V2500-A1/A5/D5 SERIES PROPULSION SYSTEMS SERVICE BULLETIN

This document transmits Revision 1 to Service Bulletin EV2500-80-0020

STARTING – PNEUMATIC STARTER – INTRODUCTION OF A PNEUMATIC STARTER WITH A VENTED
INLET HOUSING

STARTING - PNEUMATIC STARTER - VENTED INLET HOUSING

Figure 2. Modify the Inlet Housing (Part 2)

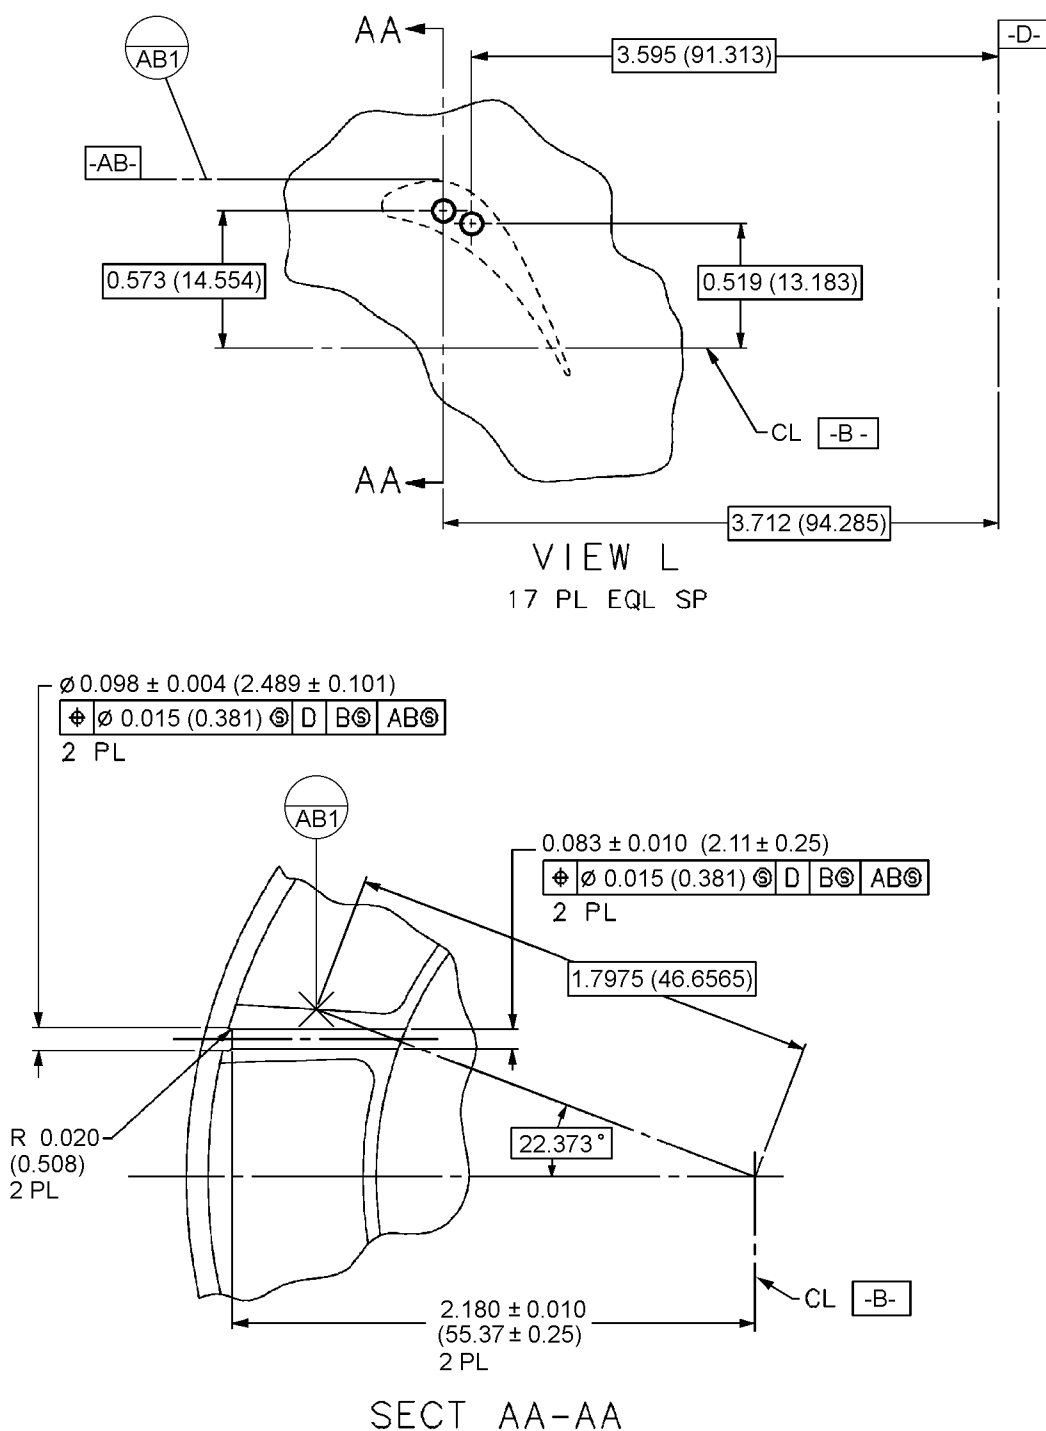
- (1) Vent holes are added to the inlet housing.
- (2) Reidentify the starter by adding L16 on the starter identification plate.

- A. Use the procedure in DISASSEMBLY of the CMM to remove the inlet housing.
- B. To change the inlet housing, (Figure 1 and Figure 2) do these steps.
 - (1) Drill holes as per View L in Figure 2. Fixture 63001014 can be used.
- C. Apply nickel plating to the inlet housing as follows:
 - (1) Mask the vented inlet holes.
 - (a) Cut a PN 69494J153 or 69494J154 preformed packing to form a string or noodle.
 - (b) Insert the string or noodle into the vent hole at one end, guiding it through the hole until it exits at the other end.
 - (2) Mask the inlet housing sleeve using lead or aluminum tape.
 - (3) Mask the housing by immersing it in lacquer per Henco-Mask Type I, or equivalent.
 - (4) Nickel plate to a thickness of 0.0005 to 0.0008 inch (0.0127 to 0.0203 mm).

NOTE: Nickel plate over nickel plate is not permitted, except fade out permissible over a 0.160 inch (4.064 mm) around vent holes.

NOTE: DIMENSIONS IN INCHES (MM).
BREAK EDGES 0.025 (0.635) MAXIMUM.
